INITIAL FIRE SAFETY INSPECTION REPORT

Factory Name: Graphics Textiles Ltd. (Extension)

Date: 18 April 2022

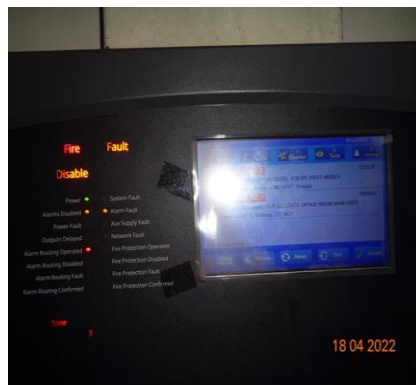
F-4	Fire Rated Construction	The fire pump room was not properly separated from other occupancy by fire rated construction. Location : Ground floor of admin building.	Provide fire pump room with 2 hr. rated fire separation by fire rated construction. Seal all unprotected opening & penetrations.. Or, Physically separate the pump room from the protected building by a minimum of 50 ft. (15.3 m) in accordance with NFPA 20.	Within 3 months
